Interactive comment on “The effect of northern forest expansion on evapotranspiration overrides that of a possible physiological water saving response to rising CO₂: Interpretations of movement in Budyko Space” by Fernando Jaramillo et al.

Response to Reviewer Nr. 2

Figure 6-Modified

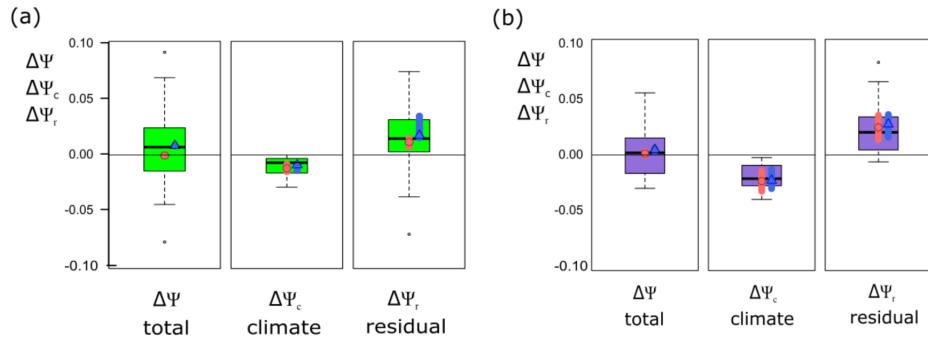
Reviewer 2: To make this point, however, I think that Figure 4 is redundant with Figure 6. Figure 4's use of “wind roses” does not add additional support for the authors' main point. While they claim that these wind roses are “a simple way to synthesize general tendencies of movement,” the general direction of these movements are well summarized by the histograms presented in Figure 6, so to me these are two different graphical representation for very similar sets of information. In addition, “spectra of movements in Budyko space,” used repeatedly in Section 3.1, need to be rephrased. Since “spectra” has a very specific meaning in time series analysis, I would suggest

On the other hand, the box plots of Figure 6 present the characteristics of each basin-group distribution (quantiles, outliers, and median) of the total, residual, and climatic components of the evaporative ratio as well as their arithmetic and area-weighted means for each group. This would be a difficult task with the roses. To address the reviewers concern, we have also used Figure 6 to include an uncertainty analysis (Please

Response 2: Thank you for both suggestions. First, we will remove any reference to “spectra” and refer to the wind-rose type diagrams as “roses” instead. We hope that this change will satisfy the reviewer. The reviewer is right in the fact that the roses (Fig. 4) and the boxplots (Fig. 6) show similar data. However, we still consider both are important for the red line of the manuscript and we think that the problem was the fact that we did not justify enough the simultaneous use of both figures. We will expand on the usefulness of each figure when analyzing the results of each figure in a revised manuscript, as follows:

see figure below and Response 2 of Reviewer 3 for more information on the uncertainty analysis) requested by reviewer 3, differentiating it even more from Figure 4. We hope that the Reviewer considers that this explanation supports the use of both figures.

Corrected Figure 8**Fig. 2.**

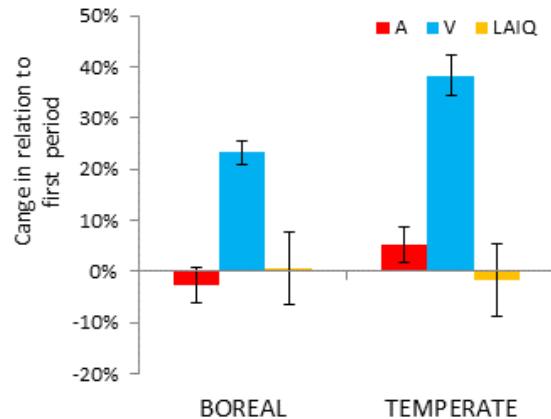
Reviewer 3: I think also that the weakness of the manuscript as it stands lies in formulating the argument for the second point, e.g., in attributing the observed increase in ET to a specific, hypothesized mechanism. In Figure 8, boreal and temperature forests showed opposite changes in this deciduous proportion, though how this might contribute to the overall increase in ET in both forest types is not discussed.

Changes in the composition of the forest (another forest structure attribute) may also have an effect in the evaporative ratio of these basin groups, however, our results showed no statistically significant change in forest composition (i.e., the ratio of deciduous leaf area index to total leaf area index, called originally LAIQ and from now on QLAI) in either of the two basin groups (Fig. 8 and 9). However, we will specify this in a clearer way, to say that the uncertainty of the experiment did not allow the detection of changes in forest composition. We also found a small mistake in the calculation of forest composition change in Figure 8 that was not showing this result in a clear way, so we have updated Figure 8 accordingly. See updated Figure below.
